DEVELOPMENT APPLICATION ASSESSMENT REPORT

Application Number:	DA2020/1755
----------------------------	-------------

Responsible Officer:	Alex Keller
Land to be developed (Address):	Lot 82 DP 5539, 3 Curl Curl Parade CURL CURL NSW 2096
Proposed Development:	Demolition works and construction of a dwelling house
Zoning:	Warringah LEP2011 - Land zoned R2 Low Density Residential
Development Permissible:	Yes
Existing Use Rights:	No
Consent Authority:	Northern Beaches Council
Land and Environment Court Action:	No
Owner:	Jessie Hannah Mitchell Michael Alexander Nikotin
Applicant:	Rapid Plans Pty Ltd

- Figure: Perspective to show open style and profile of upper storey with reasonable view sharing achieved by flat roof form and minimal excavation.

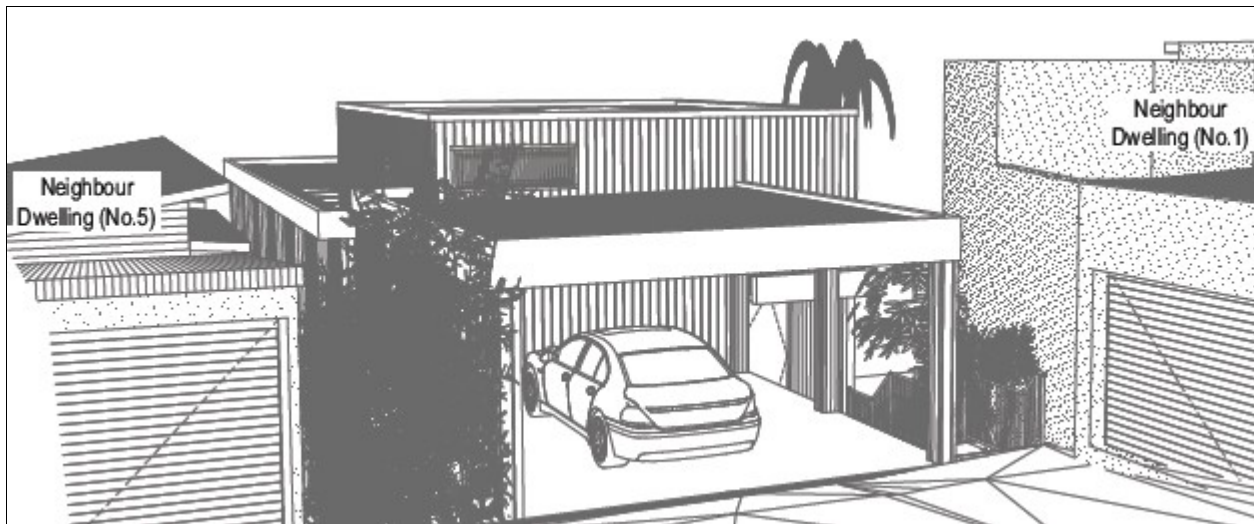
The placement of a double garage on the site does not 'enhance' or 'protect' the visual quality, therefore the use of an open style carport is more appropriate in response to this objective (see *Part C3 Parking Facilities*). At present the existing streetscape setback contains a single (original) garage and with the adjacent garages would almost completely wall-in the setback

area. However, the use of a low profile carport allows a sense of openness with opportunities for landscaping to enhance the street setback area as viewed from the public domain.
